New Mexico Oil Conservation Division approval and conditions listed below are made in accordance with OCD Rule 19.15.7.11 and are in addition to the actions approved by BLM on the following 3160-5 form.
Operator Signature Date: Original APD 3/18/2014 **Sundry Date 8/3/2017**

Form 3160-5
(June 2015)UNITED STATES
DEPARTMENT OF THE INTERIOR
BUREAU OF LAND MANAGEMENT

North Alamito Unit 330H (FKA Lybrook G31-2307 02H)

The proposed Lybrook G31-2307 02H well, which was approved by the BLM on April 29, 2014, will now be a part of the North Alamito Unit. Encana is submitting this sundry to change the well name from the Lybrook G31-2307 02H to the North Alamito Unit 330H.

WELL LOCATION AND ACREAGE DEDICATION PLAT

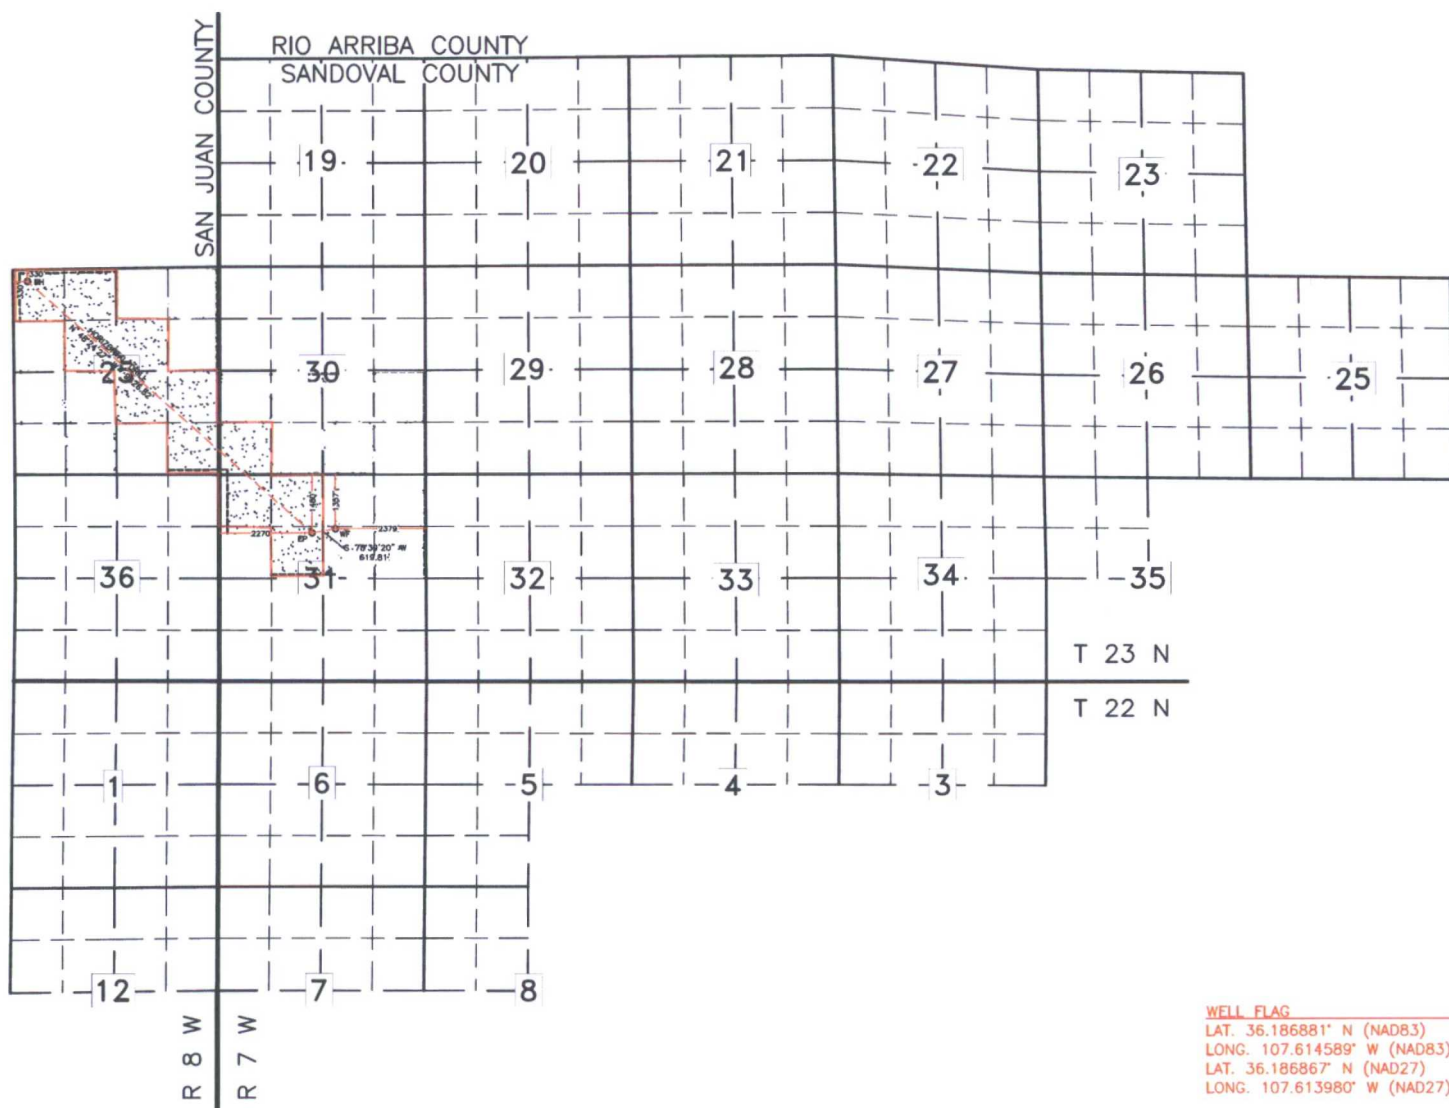
In addition to the name change, the surface hole location also changed because the wellheads were changed from a square orientation to a line orientation. Also, the BHL was modified to change the wellbore's orientation from oblique to transverse.

Project: Sandoval County, NM
 Site: S31-T23N-R7W
 Well: NAU 330H (G31-2307 02H)
 Wellbore: Hz
 Design: PLAN #8

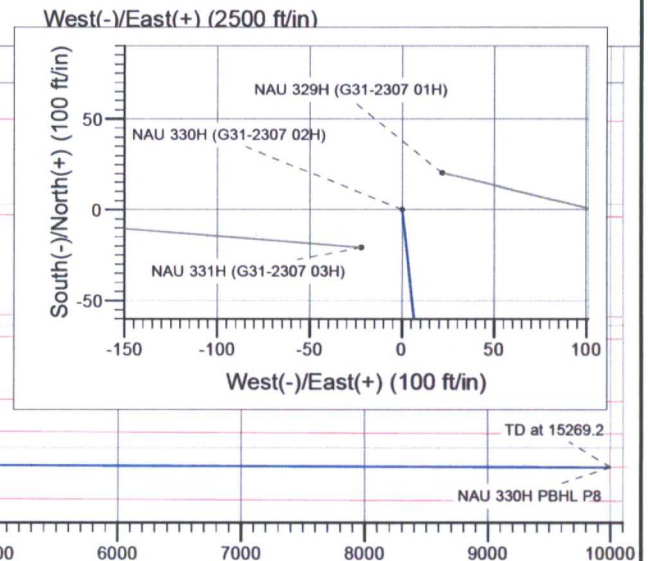
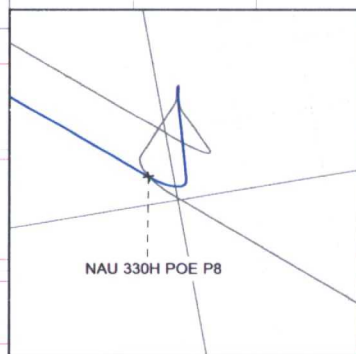
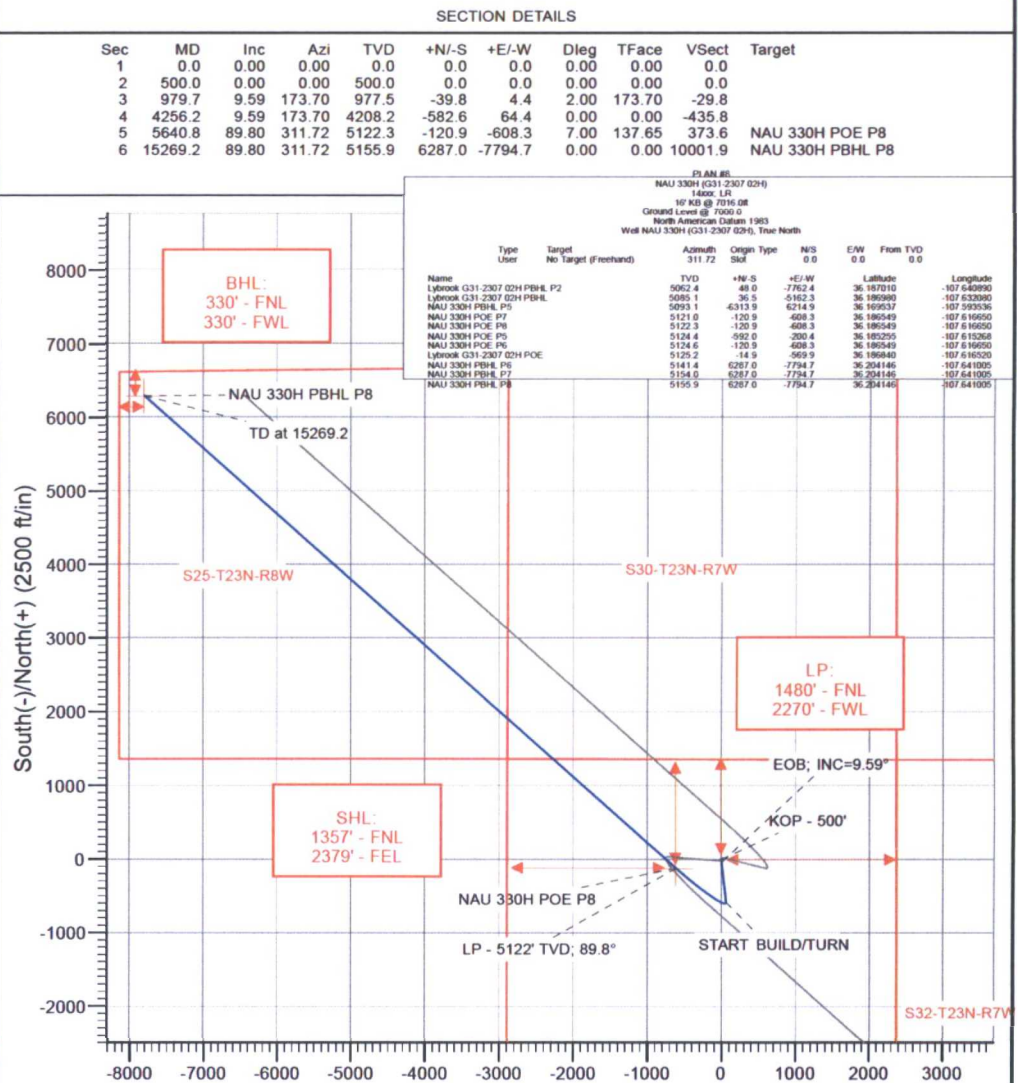
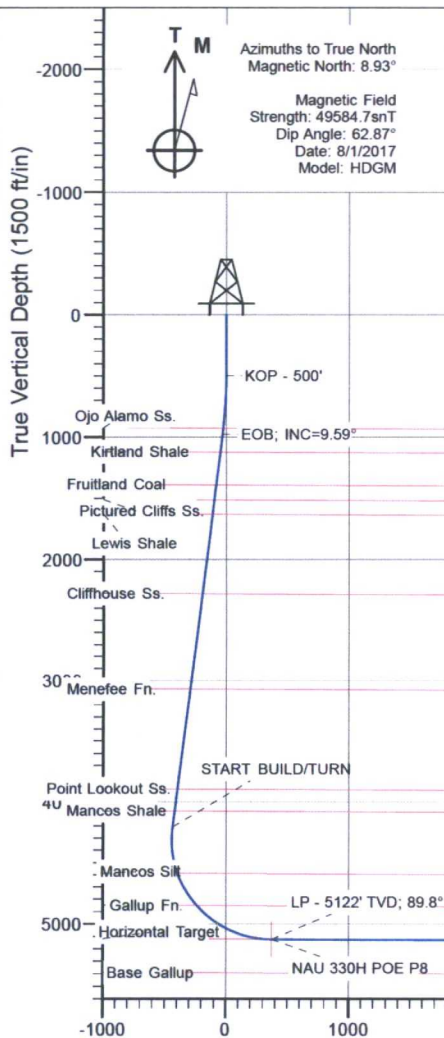
Please find attached an updated C-102, directional drilling plan, 10-Point drilling plan, and wellbore diagram that reflect these changes. Note, the drilling plans were also updated to remove the conductor.
